## **SITE INSTRUCTION NO. ME-09** **MECHANICAL AND ELECTRICAL**

**Project Name:** Carleton Place Arena  
75 Neelin Street  
Carleton Place, Ontario

**Project No.:** 205  
**Date:** 2021 January 20

**CIR # 34**

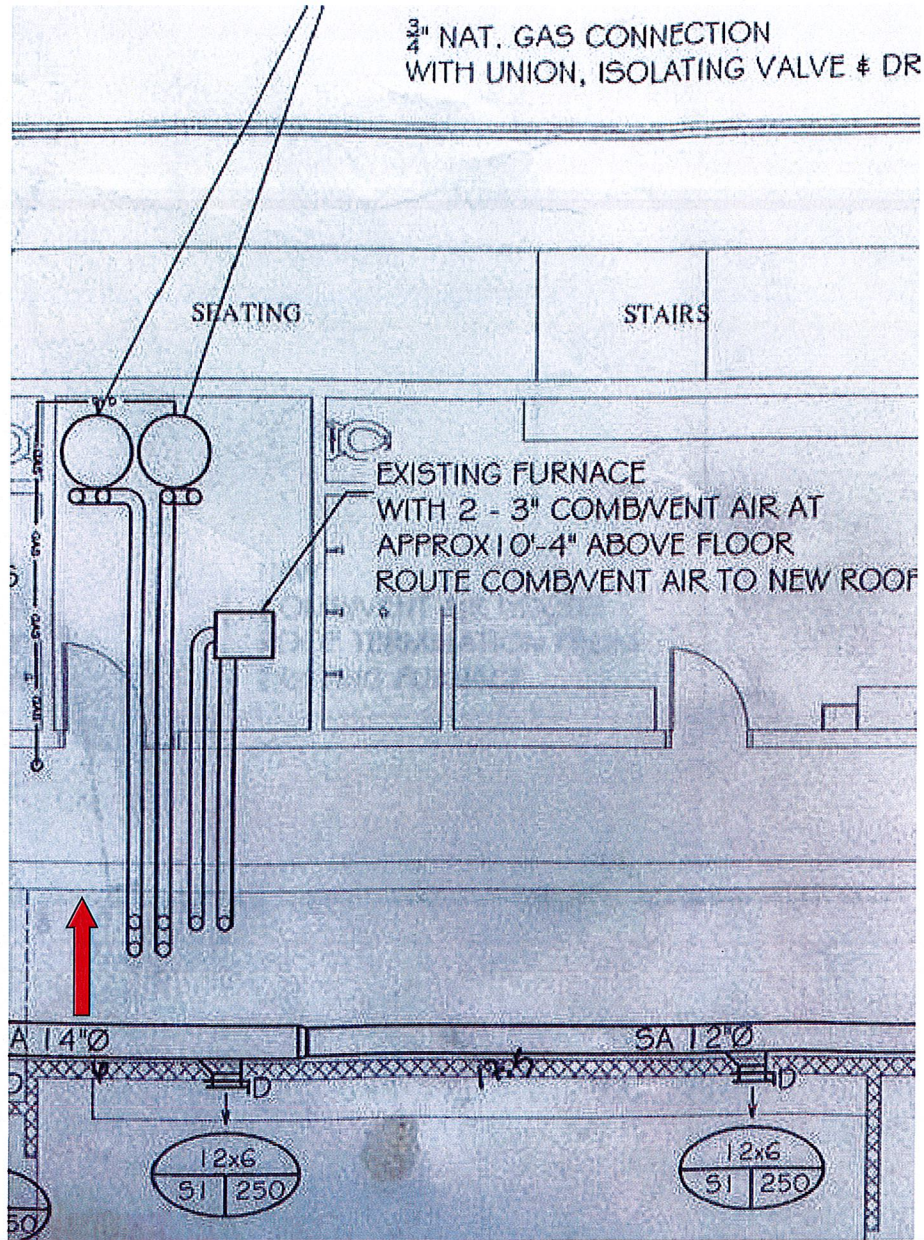
- 1. The new ductwork for the existing HRV as per Drawing M-102 will not fit through the existing East block wall without modifications to either the existing exit device and/or additional structural work to the existing wall system. Please see the photos below and provide direction.**

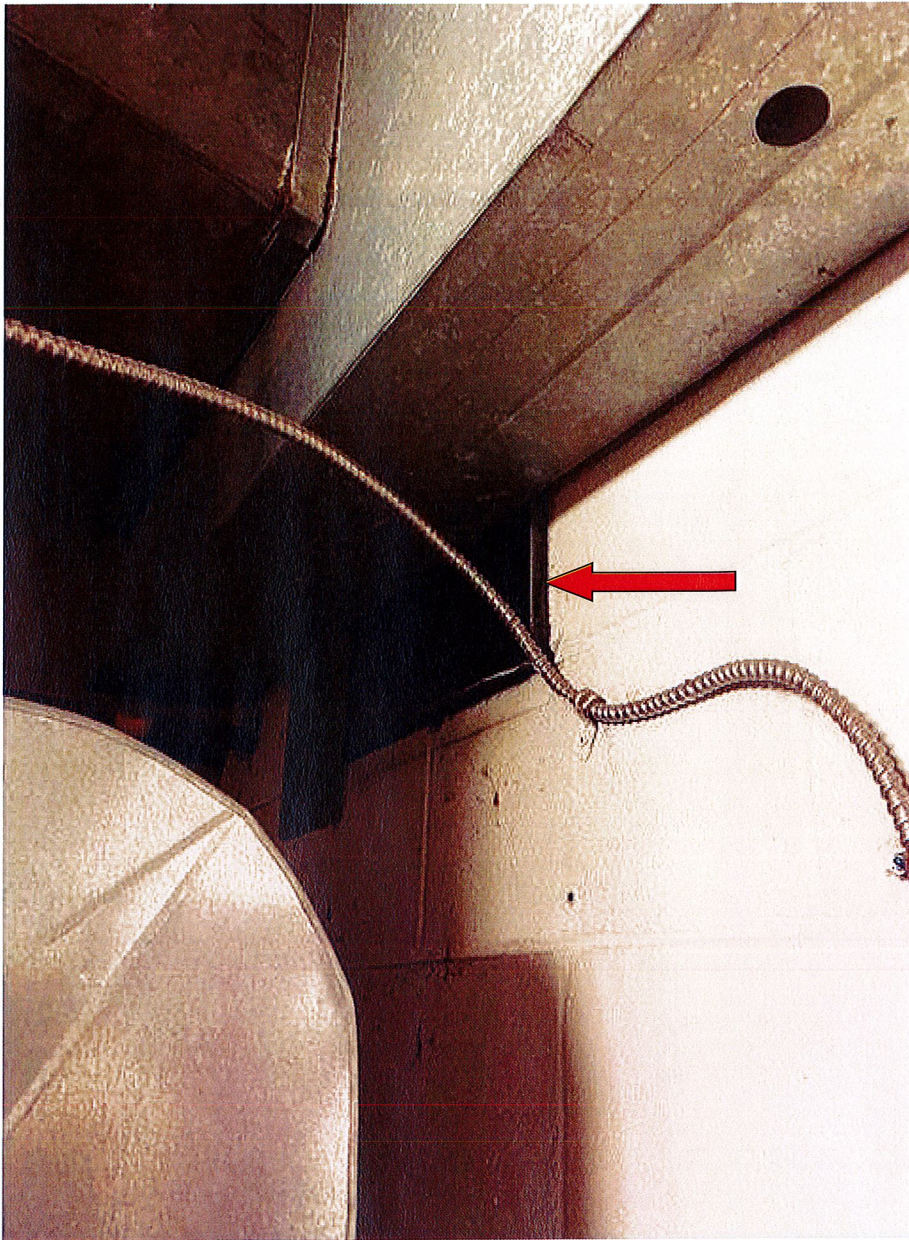
2. During the removal of the exterior cladding, we have exposed a couple duct penetrations and some ductwork that appears to lead back to the furnace room in that area. Refer to the photos below and advise if any action is required.
